TAX ID #04-311922
ON-SITE SEWAGE DISPOSAL SYSTEM
HOWARD COUNTY HEALTH DEPARTMENT
BUREAU OF ENVIRONMENTAL HEALTH

ADDRESS: 979 Route 97 PROPERTY OWNER: David Costello

SITE INSPECTION SHEET

**RE: Costello Residence
979 Hoods Mill Road
Cooksville, MD 21723
PERMIT #BO8001747
Tax Map 8, Parcel 38, Grid 6**

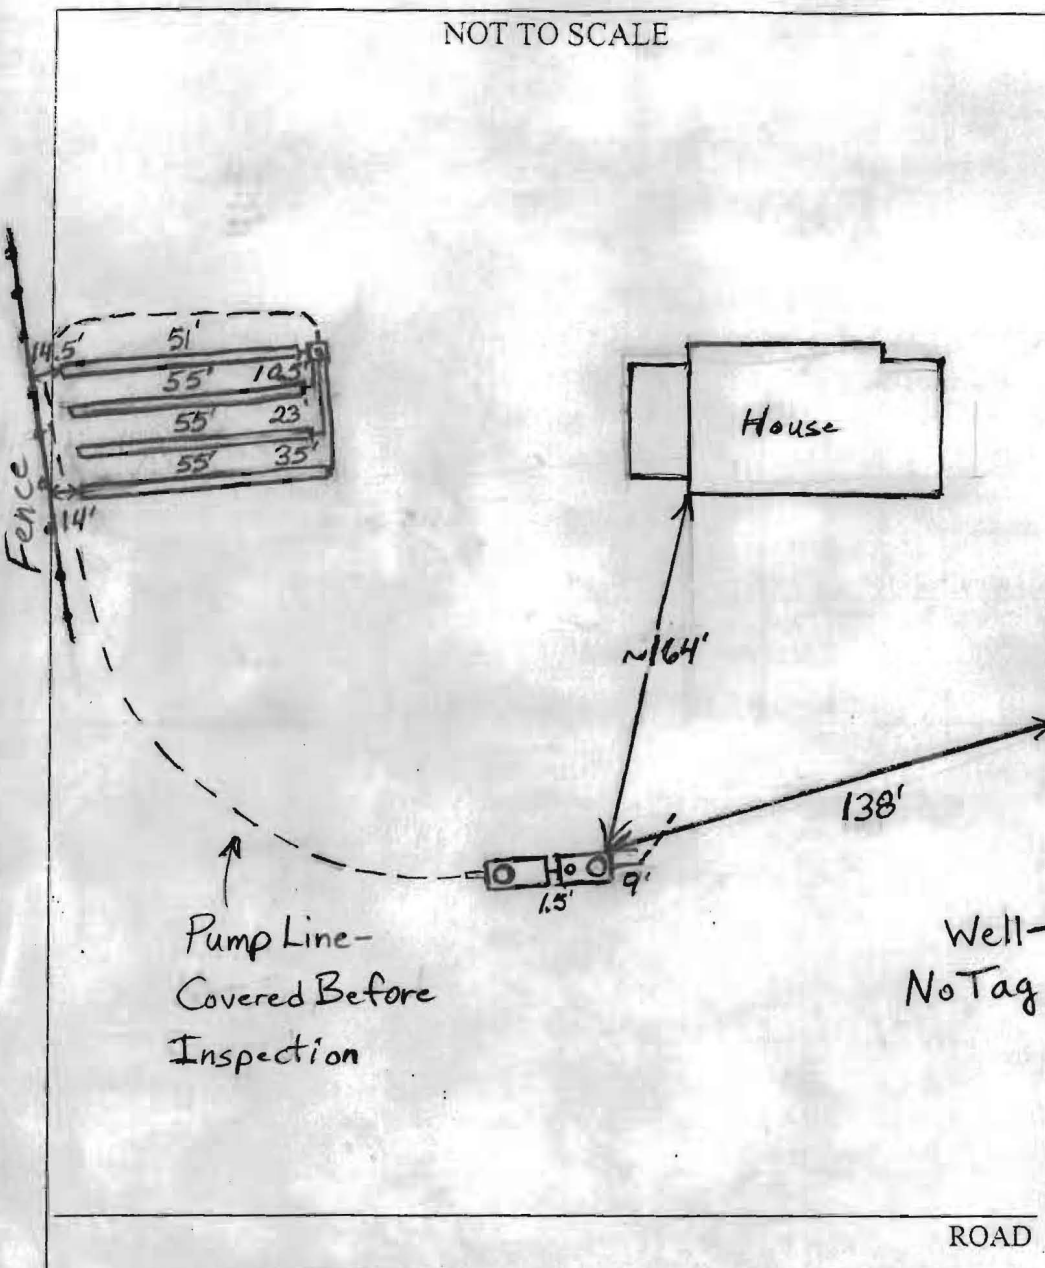
PRE-CONSTRUCTION 2/21/06 New tanks set. Old concrete tank pumped out and filled in per contractor. O.K. to install 4 trenches
 INSTALLATION towards property line (fence). The top trench ends slightly uphill of the middle of the top perc. test hole. (BB)
 3/1/06 Pump and alarm working. (BB)

LOCATION DIAGRAM

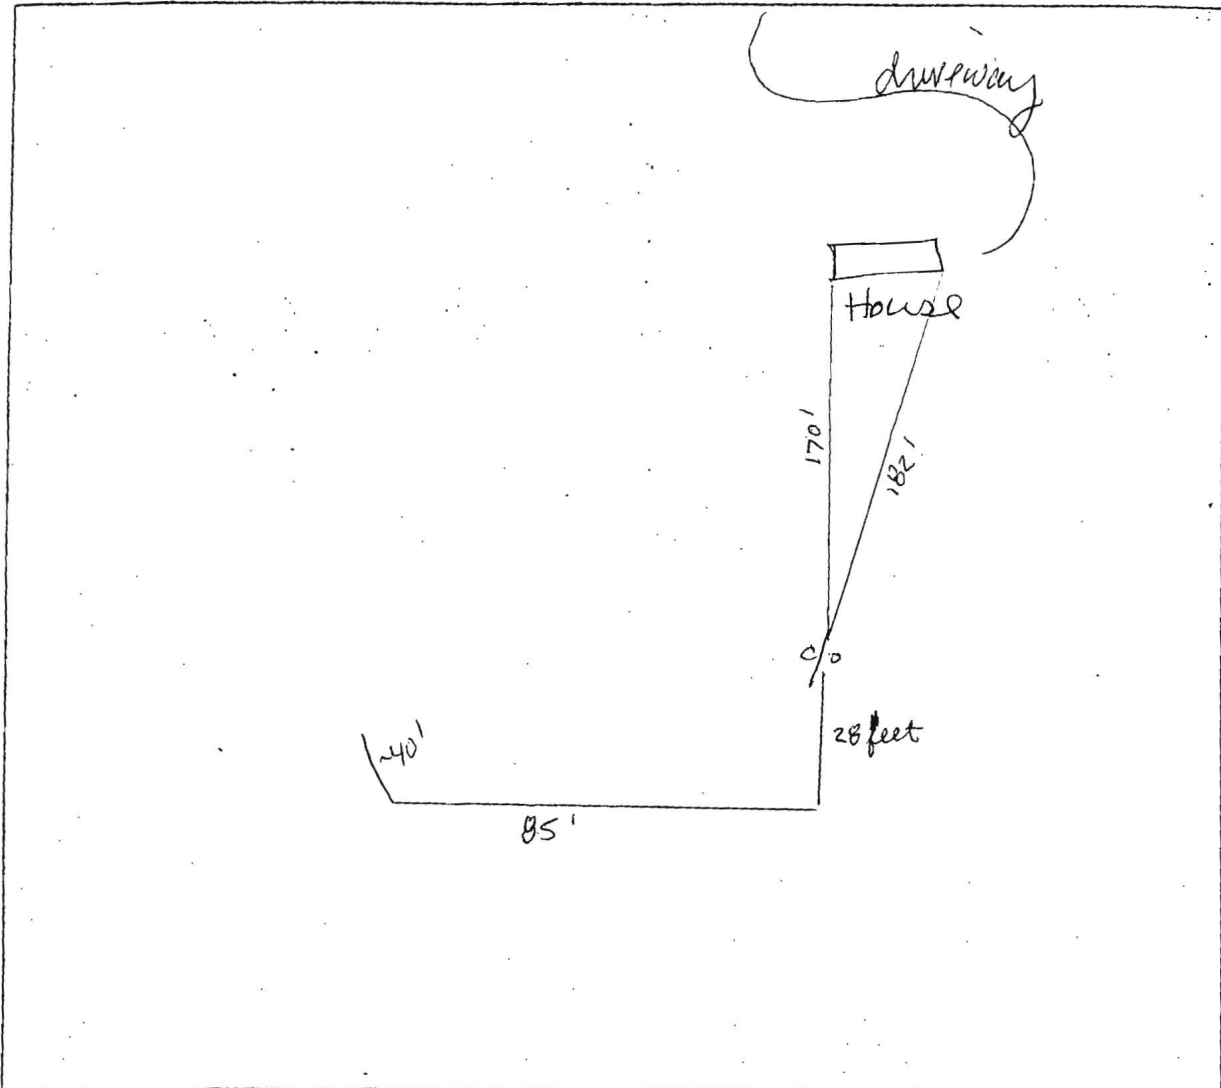
COMMENTS: will need owner to locate Dbox and excavate Dbox and end of trench possibly will need to excavate middle of trench to filter paper

LOCATION DIAGRAM

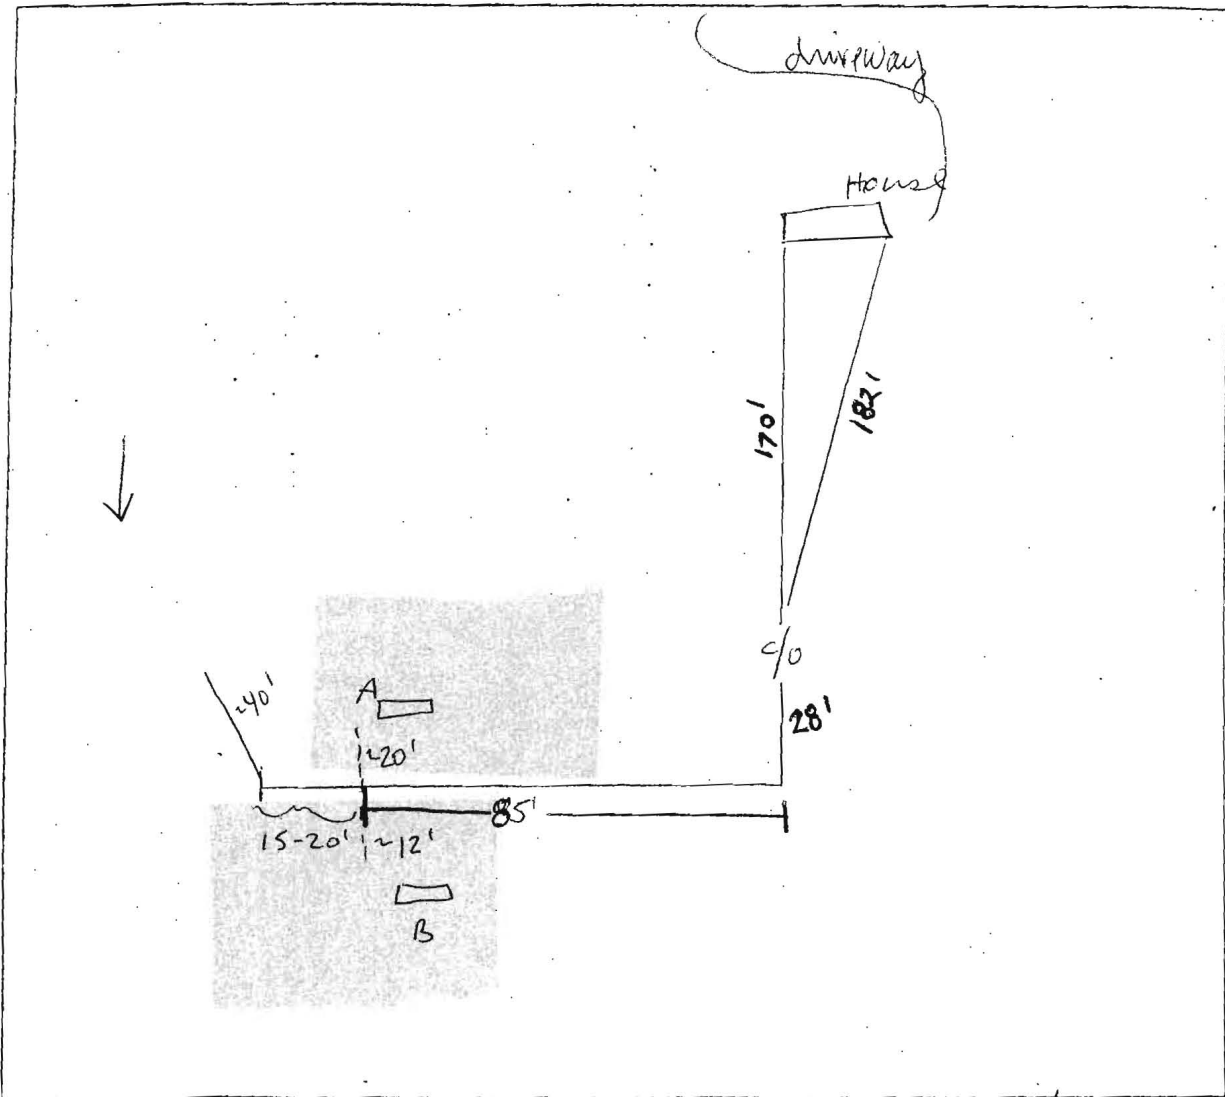
COMMENTS: Inlet ~3'5"-4' below grade, filter cloth visible, wrong type of stone (had 57 stone which is less than required). System visibly failing due to ~5' H₂O above pipe. Probing found ~6"+ of stone below pipe. no obx
2/15/06 (SF)
